ADDENDUM 3

BID TITLE: File No. 55-24 Green Road Pump Station

ADDENDUM NO. 3

REVISIONS NO. DATE BY		CITY OF CLEVELAND CLEVELAND DIVISION OF WATER DEPARTMENT OF PUBLIC UTILITIES CLEVELAND, OHIO
SUBJECT: CYCLE H - GREEN PUMP STATION OVERALL PUMP STATION P&ID		
DRAWN BY: L.R. CHECKED BY: L.R. DESIGNED BY: W.	SCALE: 1/8" = 1'-0" DATE: 12/20/11	SHEET NO.: I-04

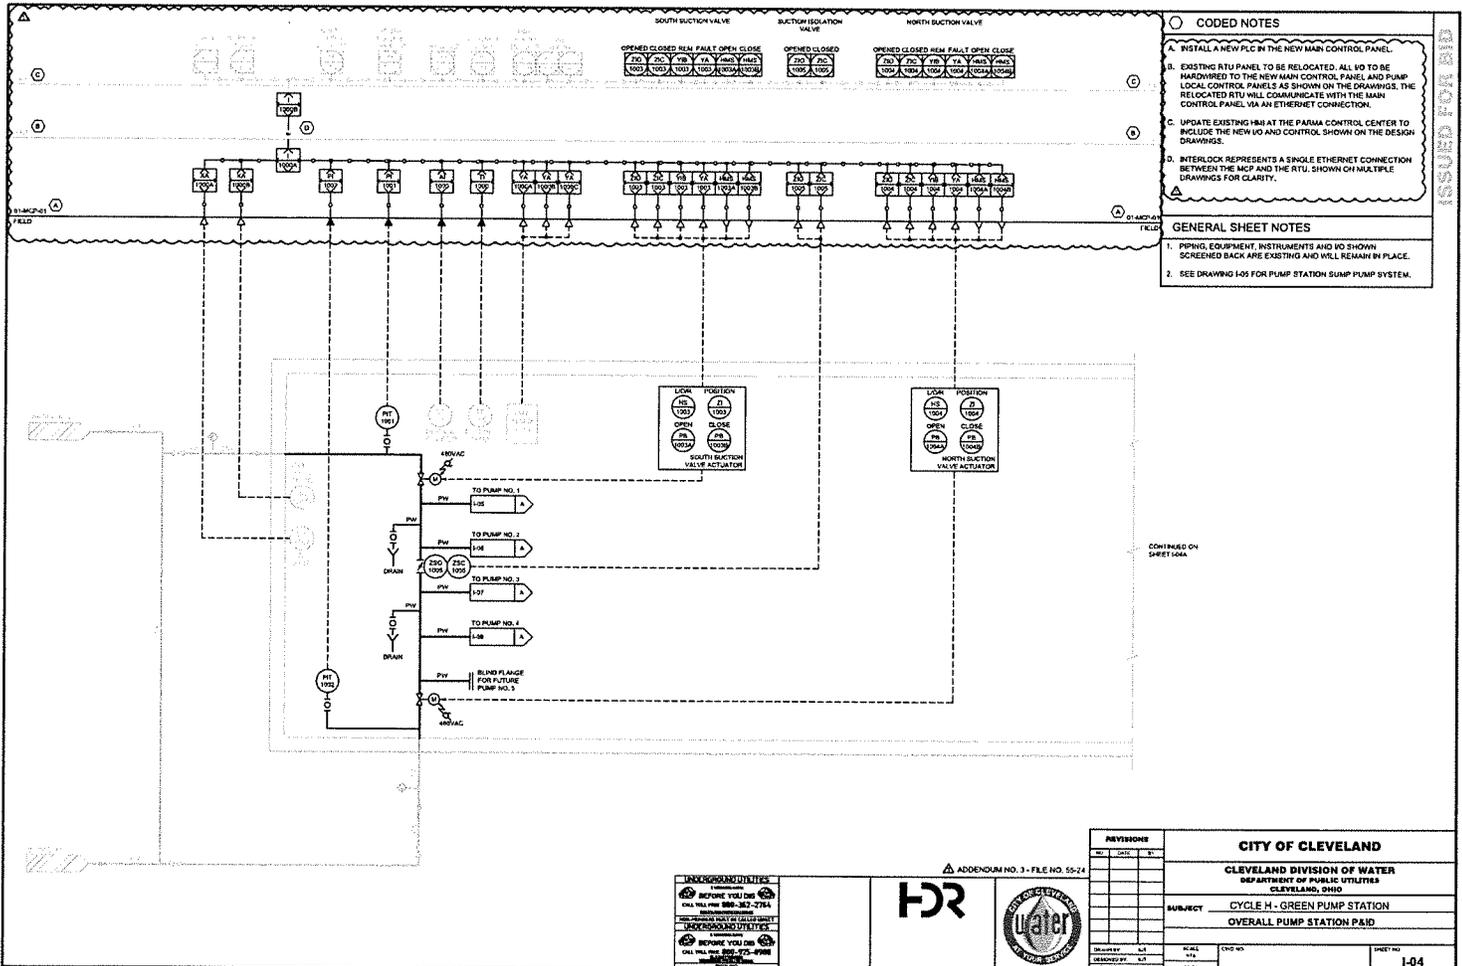
16. Drawing I-04 shows a number of existing points that do not appear to be indicated on the RTU Loop Drawings. An example is the Chlorine TI-1000 point. Are these points to be landed in the "Marshalling Cabinet"? Is it to be assumed that all points new and existing shown on drawings I-04, I-04A, I-05, I-06, I-07, and I-08 are to be landed in the "Marshalling Cabinet" prior to being pulled to the RTU?

Answer: This is indicated in the updated I drawings above. Marshaling Panel drawings have been removed and PLC Panel drawings have been added.

CITY OF CLEVELAND	
CLEVELAND DIVISION OF WATER DEPARTMENT OF PUBLIC UTILITIES CLEVELAND, OHIO	
SUBJECT: CYCLE H - GREEN PUMP STATION	
FIRST FLOOR	
POWER PLAN	
DATE: 10/1/2015	SHEET NO. E-06

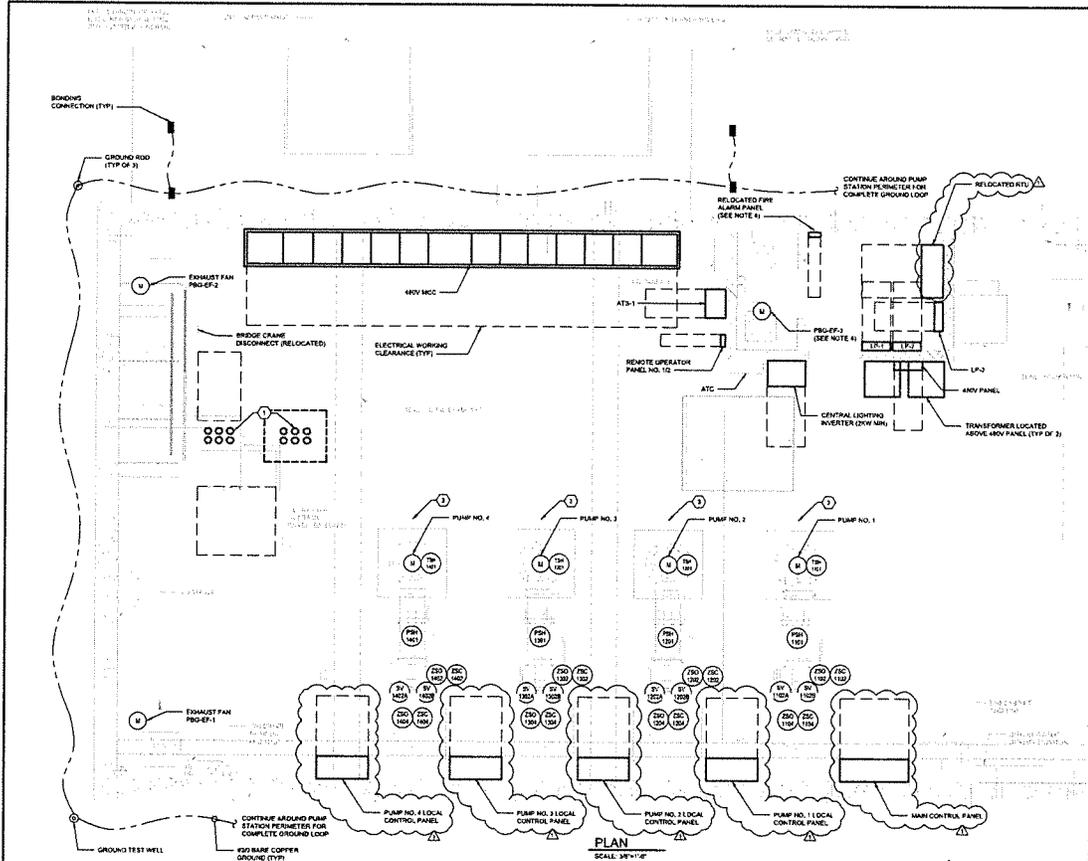
1. G-02: updated drawing index to indicate changes to numbers and titles of I sheets
2. C-03: updated to include concrete repair detail
3. E-06: updated to show the addition of the Local Control Stations (RIOs), the Main Control Panel (PLC), and relocated RTU
4. E-11: updated to show revised LP2 Panel Schedule for addition of four LCPs and updated Main Control Panel
5. E-12: updated to show revised conduit riser for addition of four LCPs and updated Main Control Panel
6. I-04 thru I-08: updated to indicate relocation of RTU panel and installation of new PLC panel
7. I-09 and I-10: new sheets with new pump Local Control Panel detail
8. I-10A and I-10B: new sheets with new Main Control Panel details
9. I-12, I-14 thru I-22: new/updated sheets to provide networking and loop drawings for new PLC panel and pump Local Control Panels
